PLAN COMMISSION STAFF REPORT

Agenda Item: PC Docket No. 22-005

Application Type: **COMMERCIAL SUBDIVISION – PRELIMINARY PLAT**

Summary: Community Foundation of Northwest Indiana requesting approval of a preliminary plat for a 3-lot commercial subdivision at 10240 Calumet Avenue

Figure 2 Applicant-proposed Treadway Drive Extension

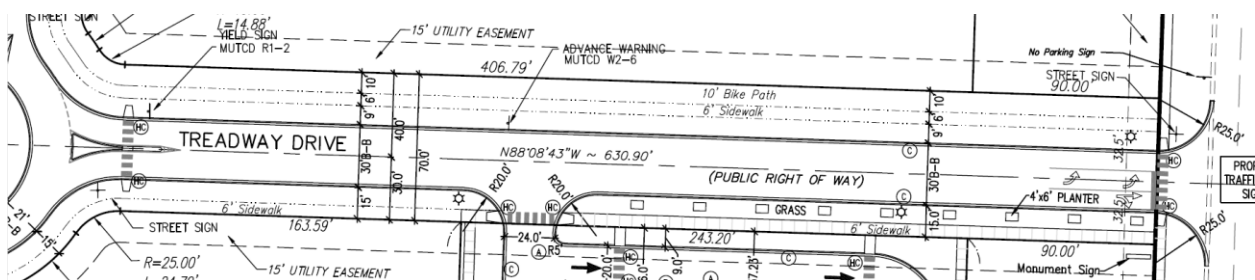
All streets must conform to the standards of one of the Thoroughfare Types listed in the Munster zoning ordinance. There are 6 possible Thoroughfare Types, each with multiple acceptable Bikeway Types, that can be implemented in a CD-4.B zone. Each of these have been designed to match the character of the land use in a CD-4.B district. The Thoroughfare Standards and Bikeway Types have been included as attachments. Staff notes that the proposed 70' right-of-way of Treadway Avenue or even a 60' right-of-way could accommodate a number of the Town's standard Thoroughfare Types. With respect to Don Powers Drive, it does not appear to have a consistent design its entire length, so staff would recommend implementing a Town Thoroughfare Type along its extension as well.

The Thoroughfares Plan should also include compliant street lighting and street trees.

SHEET
C-2.1

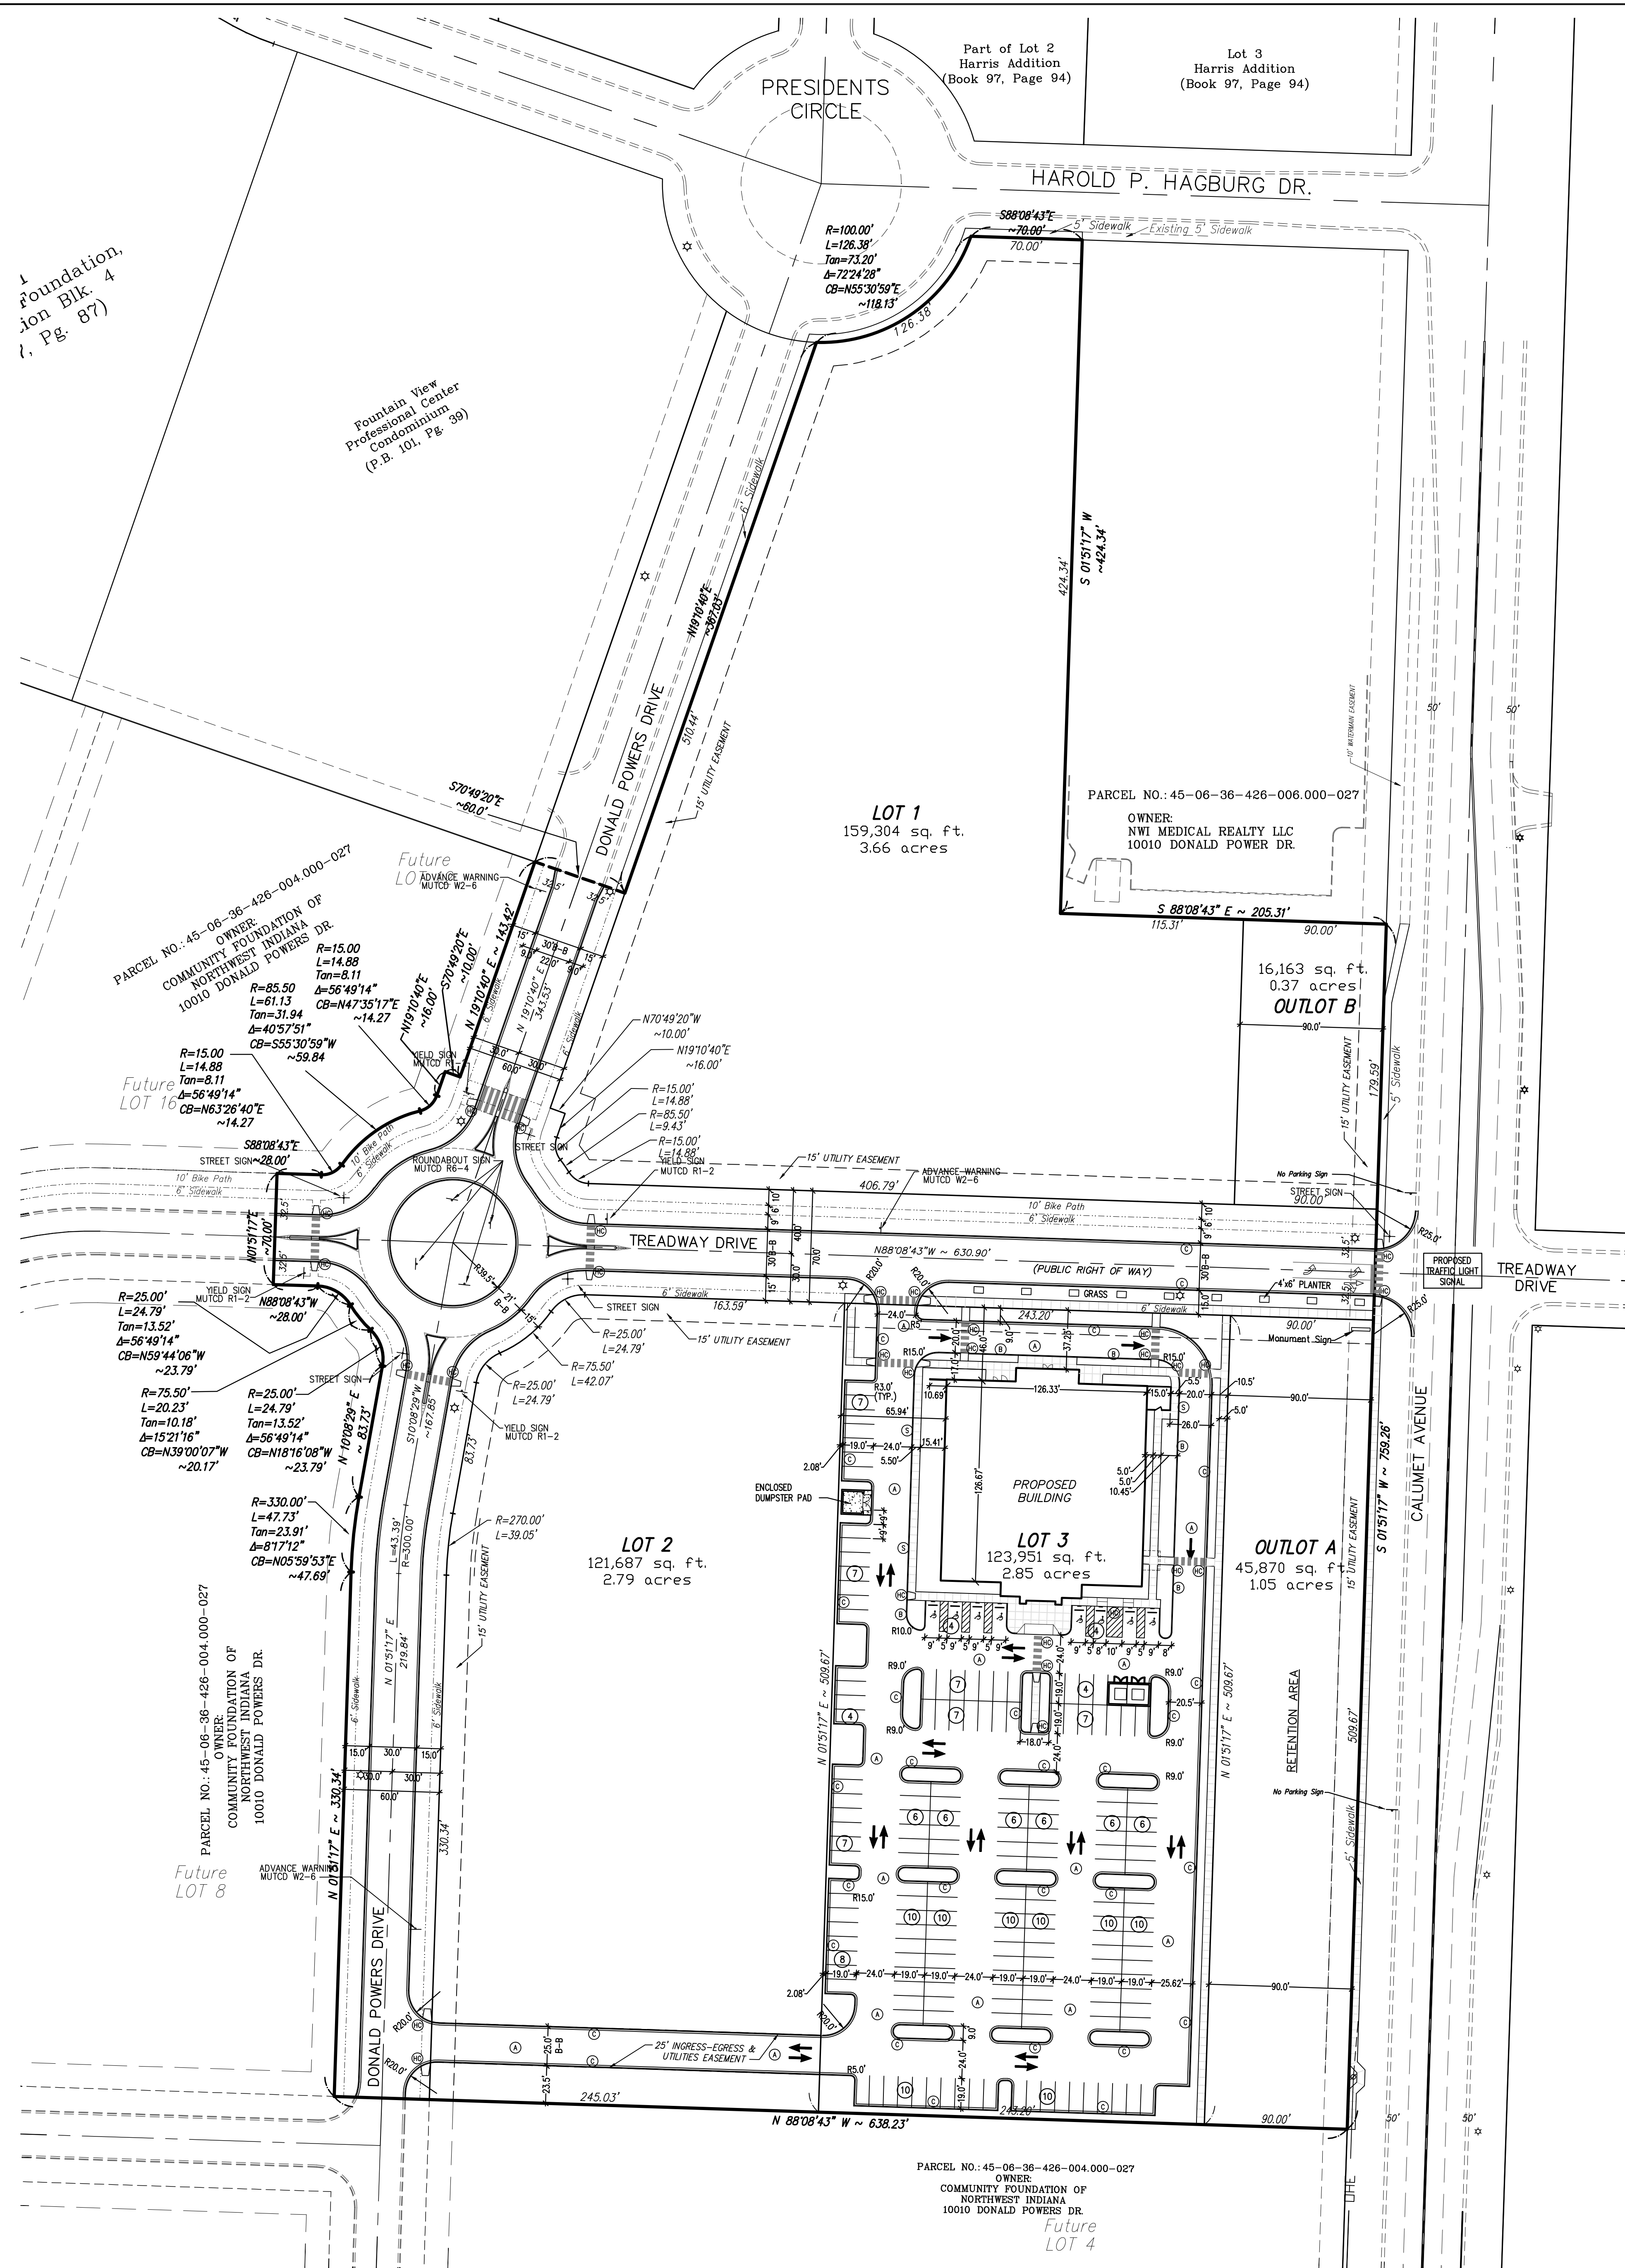
1. The parking lot setback along the west side of the property must be widened to a minimum of 3' to accommodate shrubs and 5' to accommodate trees.
2. The drop off aisle and drive aisle along the north and east sides of the building shall be no wider than 18' to accommodate one parking row and one drive aisle.

The plans include a note for a *Proposed Traffic Light Signal* at Treadway Drive and Calumet Avenue. Staff recommends that the conditions for a traffic signal be included in the approval of these plans and that the intersection design be subject to the approval of the Town Engineer.
